**PLANNED UNIT DEVELOPMENT
& SUBDIVISION STAFF REPORT****January 16, 2014****DEVELOPMENT NAME***Mercedes-Benz of Mobile***SUBDIVISION NAME**

Northside / Joint Venture Suddivision and American Red Cross Subdivision, Lot 2, Resubdivision of Lot 1

CONTEMPLATED USE*Planned Unit Development Approval to amend two previous Planned Unit Development Approvals to allow shared access and parking between two lots, and allow multiple buildings on a single building site and to create two legal lots or record from two existing legal lots.***TIME SCHEDULE
FOR DEVELOPMENT**

SITE PLAN

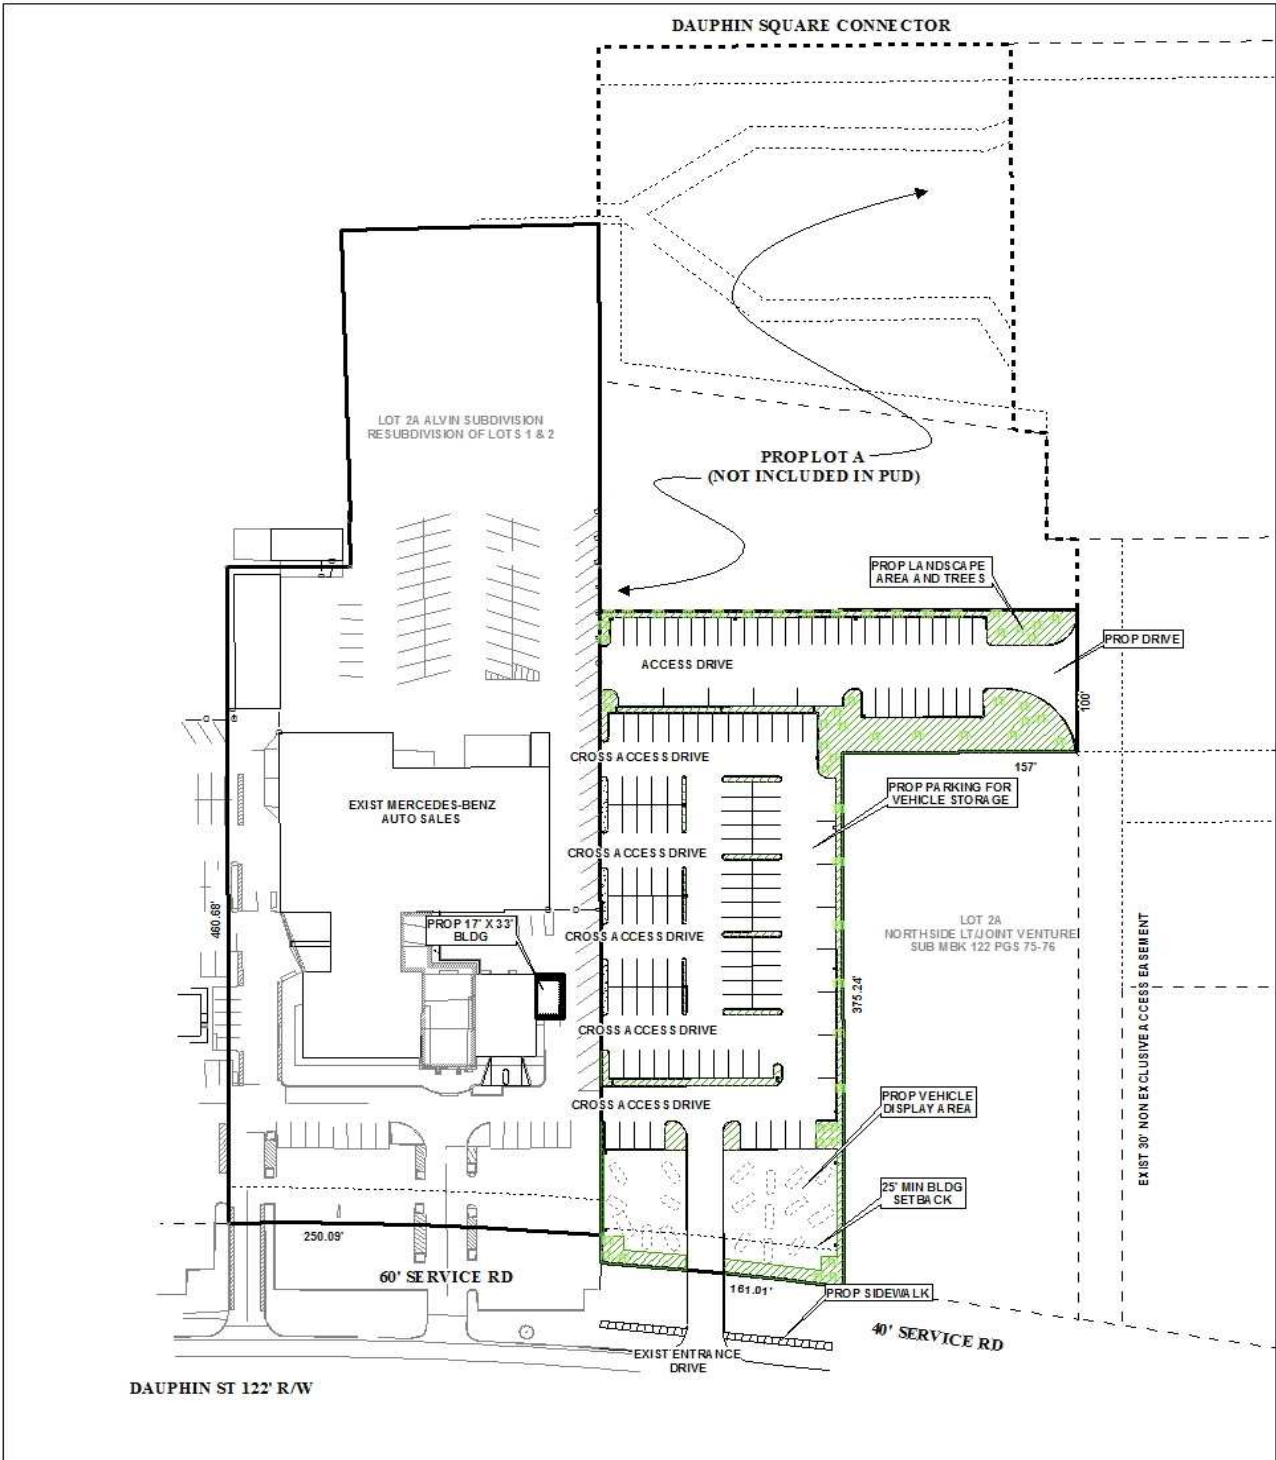
The site plan illustrates the construction of a new proposed building, for office space, as addition to an existing auto dealership building. As a result of the proposed expansion and its close proximity to the parking spaces and travel aisle, the elimination of parking spaces along the East property line to provide a 20’ wide access and maneuverability for a fire apparatus will be required.

It should be noted one of the owners has raised concerns regarding the access to the private street for individuals besides the Mercedes Benz dealership and their customers. The PUD site plan does show direct access from the rear of the existing Mercedes property across the new lot to the private drive. The plan does not show however, if there is any existing fences between the Mercedes-Benz dealership and the McConnell dealership to the West to prevent access and use. Private or public access to a private street is a matter that should be resolved between the property owner(s) and the applicant. The site plan does not illustrate any proposed fencing or gates that would prevent public access from the private street to Mercedes-Benz and vice versa. A revised site plan should be submitted to depict fencing or gates to address the public access concerns. This matter should be heldover to allow staff and other departments to review the revised site plan.

As the site is subject to PUD review, the requirements of the tree and landscaping provisions of the Zoning Ordinance will be applied. The site being redeveloped is required to provide 5 frontage trees, 47 perimeter trees, and 7 parking trees. The site plan depicts 6 frontage trees, and 47 perimeter trees. A revision to the site plan to depict a total of 59 trees is required. A note on the site plan states "since no building is proposed for the site, landscaping is distributed throughout the site". Although there is no building on the lot, the project is associated with the adjacent dealer, thus the existing building line from the Mercedes-Benz dealership should carry over to the adjacent lot to define the front landscape area. Sixty percent of the required twelve percent of total landscaping should be provided in the front landscape area.

The Zoning Ordinance requires that areas used for the parking and storage of vehicles be paved in asphalt, concrete or similar approved surface. The Ordinance also requires 24-foot wide driveways for two-way access. This information is depicted on the site plan however; any additional area needed for parking or storage of vehicles will require additional paving as well as a revised PUD application.

- 1.) revision of the site plan to eliminate parking spaces along the East property line of Lot 2A to provide a 20' wide access and maneuverability for a fire apparatus;*
- 2.) revision of the site plan to illustrate gates or fencing to prevent cross access from Lot 2A and proposed A, or revise PUD application to include Lot A;*
- 3.) revise the site plan to show fencing/ gates to prevent unauthorized access to the private street;*

- 4.) *revise site plan to depict frontage landscaping as measured from the Mercedes-Benz building line up to the property line for the south portion of Lot B;*
- 5.) *revision of the site plan to show all existing or proposed fences or gates that currently or will be used to control access between Mercedes-Benz, McConnell, proposed Lot A and the private street to the East of the proposed Lot B; and*
- 6.) *revise site plan to depict a total of 59 trees.*

DETAIL SITE PLAN

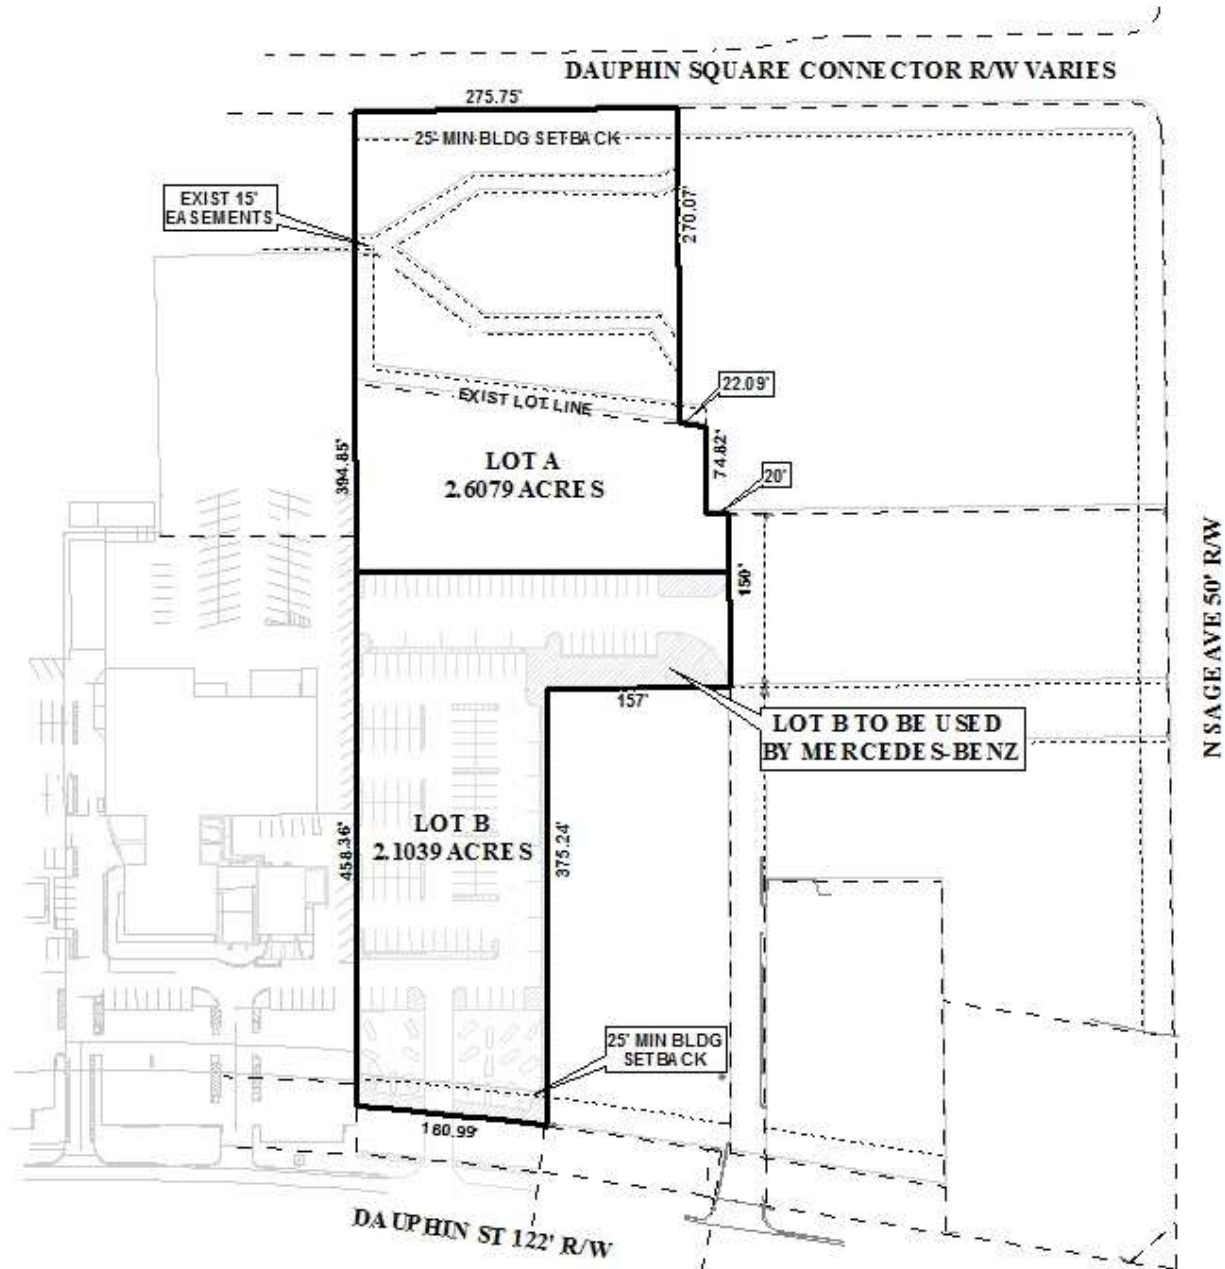
The plat illustrates the proposed 2 lot, 4.7 ± acre subdivision which is located on North side of Dauphin Street, 355' ± West of North Sage Avenue, extending to the West side of North Sage Avenue, 180' ± North of Dauphin Street, in Council District 1. The applicant states that the subdivision is served by city water and sanitary sewer.

Access management is a concern thus; a note should be placed on the Final Plat stating the site should be limited to one curb-cut onto the Dauphin Street, and one curb-cut to Dauphin Square Connector, with the size, design and location to be approved by Traffic Engineering, and conform to AASHTO standards.

The 25' minimum building setback line is indicated on the preliminary plat; and should be retained on the Final Plat, if approved.

The proposed Lot A currently has drainage easements that run throughout property. There is a note located on the preliminary plat that states, "*this drawing does not reflect any title, easement or right-of-way research other than what is readily visible on the surface or provided by the client*". A note should be placed on the Final Plat stating no structures shall be constructed or placed in any easements.
